<b>DOCKETED</b>	
<b>Docket Number:</b>	23-OPT-02
<b>Project Title:</b>	Darden Clean Energy Project
<b>TN #:</b>	260662
<b>Document Title:</b>	CEC Supplemental Data Request Response Set 1
<b>Description:</b>	Provides the Applicant's first and final response set to supplemental data requests received from the CEC. Responses address data requests related to Air Quality, Biological Resources, Climate Change/Greenhouse Gas Emissions, Hazardous Materials Handling, Project Description, Public Health, Water Resources, and Worker Safety.
<b>Filer:</b>	Megan Knight
<b>Organization:</b>	Rincon Consultants, Inc.
<b>Submitter Role:</b>	Applicant Consultant
<b>Submission Date:</b>	12/13/2024 4:44:37 PM
<b>Docketed Date:</b>	12/13/2024

# Darden Clean Energy Project (23-OPT-02)

## CEC Supplemental Data Request Response Set #1

Figure 1 Updated Emergency Backup Generator Modeling Locations (Figure 1 Data Response Set 3)

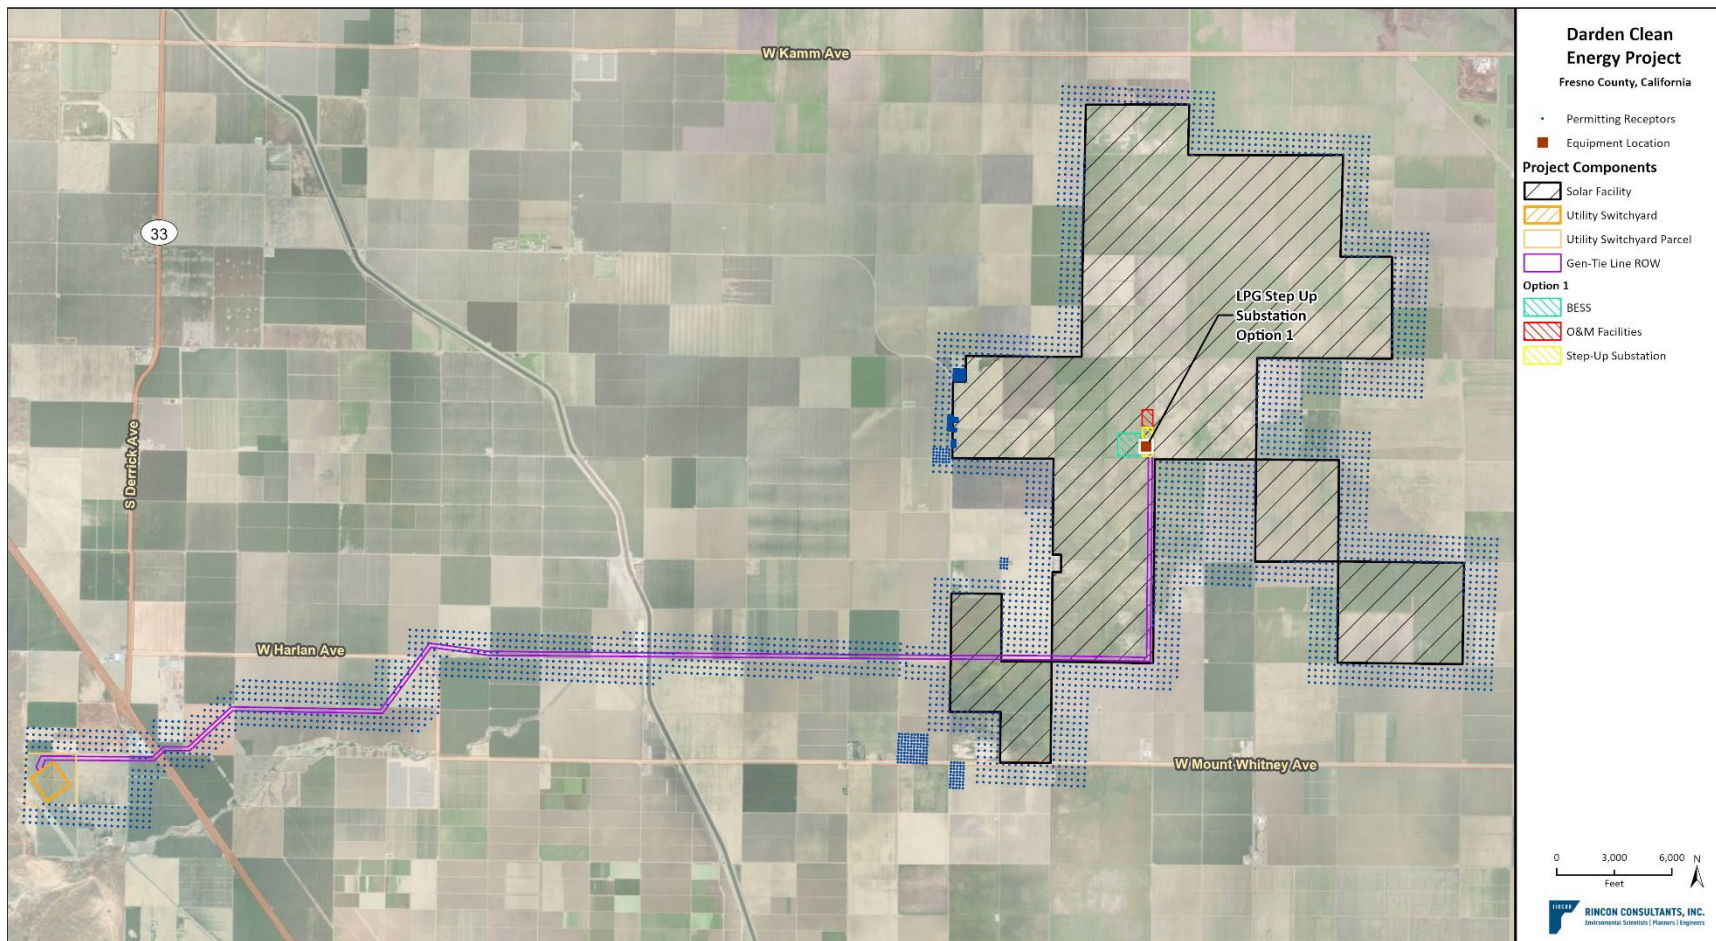
**SUP DR AQ-1:** Please provide an updated Figure 1 of Data Request Response Set 3 (TN 255907).

**Response:** The updated Figure 1 of Data Request Response Set 3 is provided as Figure 1 below. The updated figure depicts the removal of the diesel emergency generators (gensets) due to removal of the green hydrogen component, and shows the location of the up to three liquid propane gas (LPG) gensets.
